CAPP 2010-0002

New Residential Construction

*Waterford Historic District*

# CAPP 2010-0002 | Madison Residence

## Massing

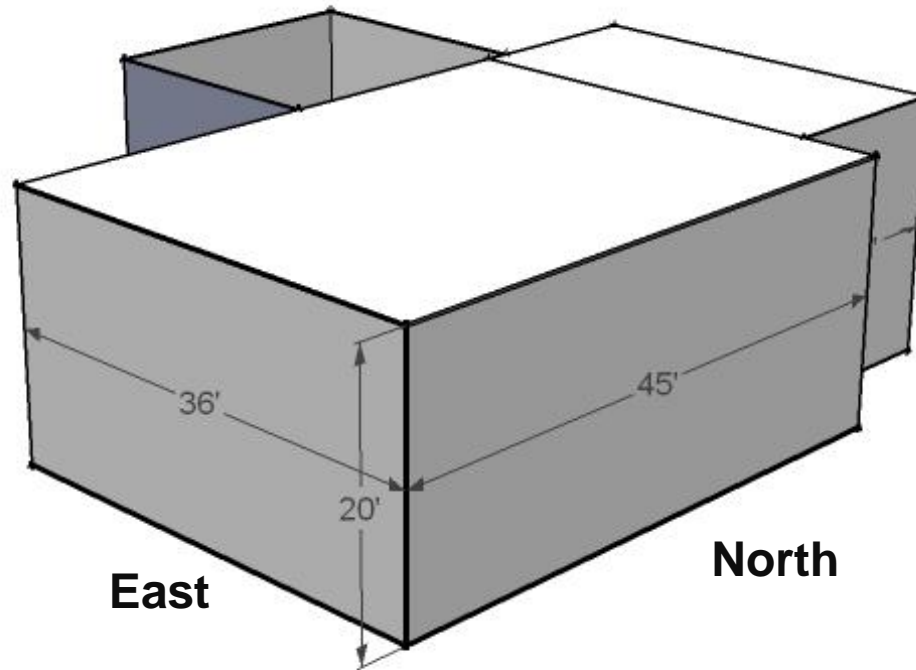
- *Massing should relate to **existing adjacent historic buildings**,*
- *Where a building footprint is larger than **historic precedents**, then refer to examples of historic buildings that grew over time for guidance on how to reduce the perceived mass,*
- *Reduce the perceived mass by dividing the building into simple differing masses with varying and intersecting rooflines, and*
- *Maintain the precedent of one primary mass with one or more secondary masses*

- Broken up into three masses with a primary mass (*meets Guidelines*)
- Footprint of main block (43' wide and 36' deep) is larger than historic precedents (*does not meet Guidelines*)

# Madison Residence | Side (W) Elevation

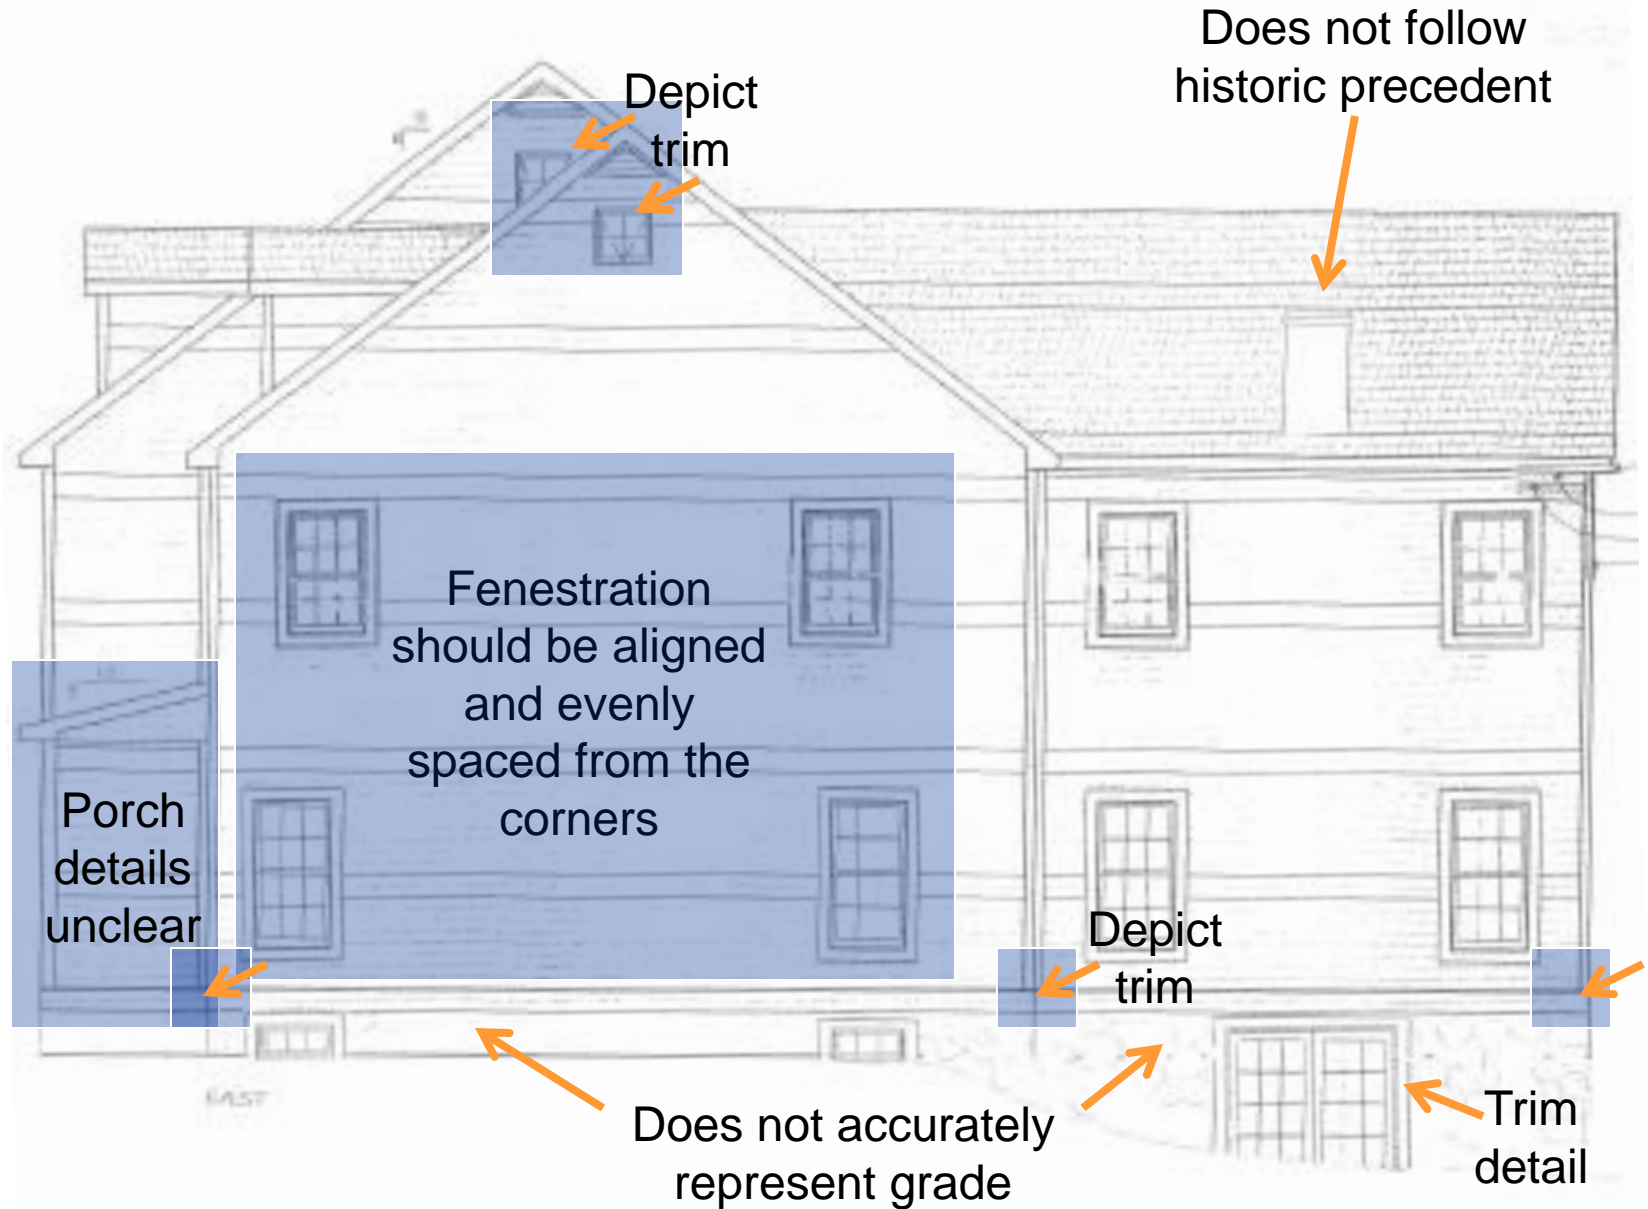
- Reduction from 5 dormers to 3 dormers in the façade of the main block,
- Reduction of west wing width by 1 foot,
- Stone porch post and flagstone porch floor, and
- Revised fenestration in west elevation of west wing and east elevation of main block.

- 7.) Proposed front porch floor of flagstone and the stone support.  
A balustrade may be required based on the change in grade witnessed during a site visit.
- 8.) Reduction from 5 dormers to 3 dormers in the façade of the main block.
- 9.) Reduction of west wing width by 1 foot.
- 10.) Revised fenestration in west elevation of west wing and east elevation of main block.

# Madison Residence | Rear (S) Elevation

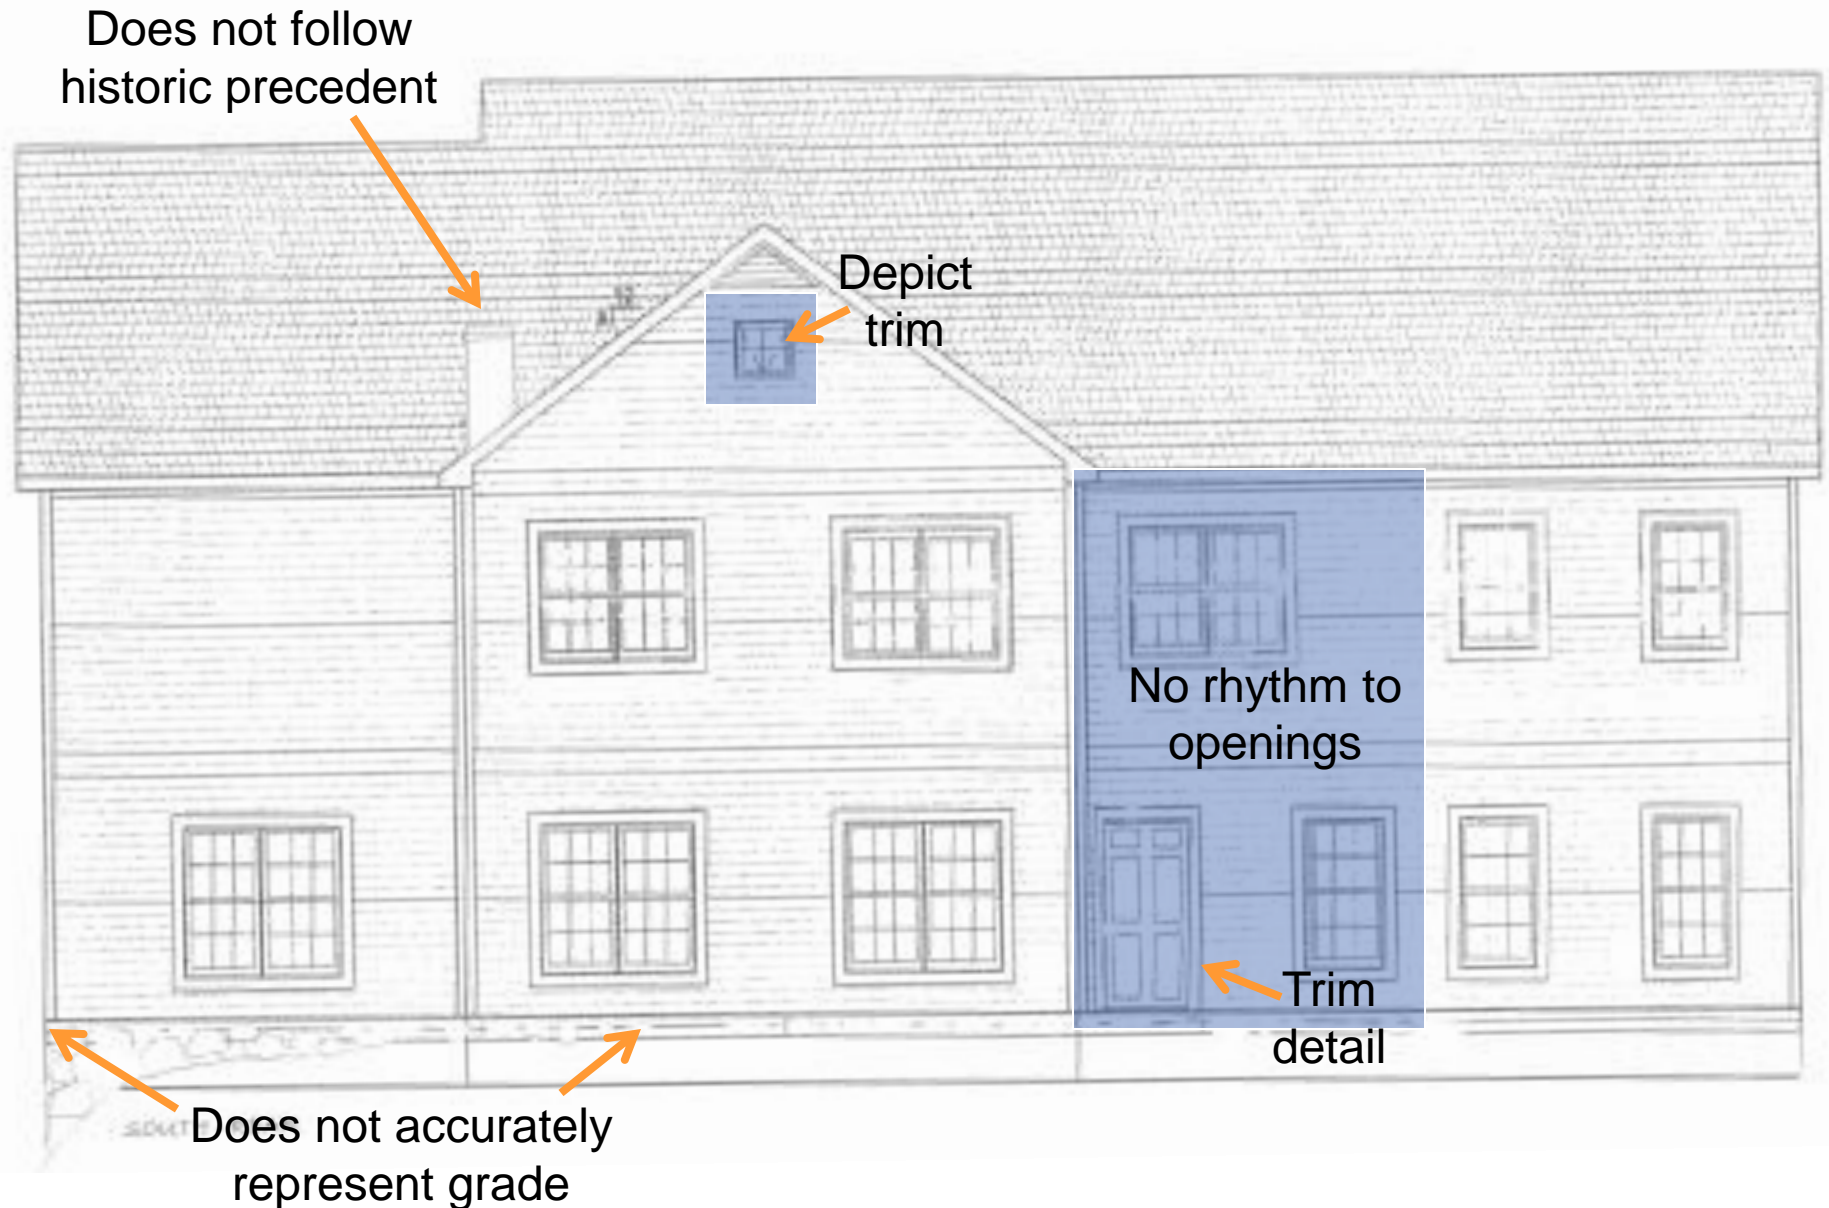
- Decrease from 7 bays to 5 symmetrical bays in the façade (north elevation) of the main block,
- Relocation of chimney to gable end of rear ell,
- Windowsills are proposed,
- Extension of corner boards to foundation, and
- Revised fenestration in rear elevation of main block and east elevation of rear ell.
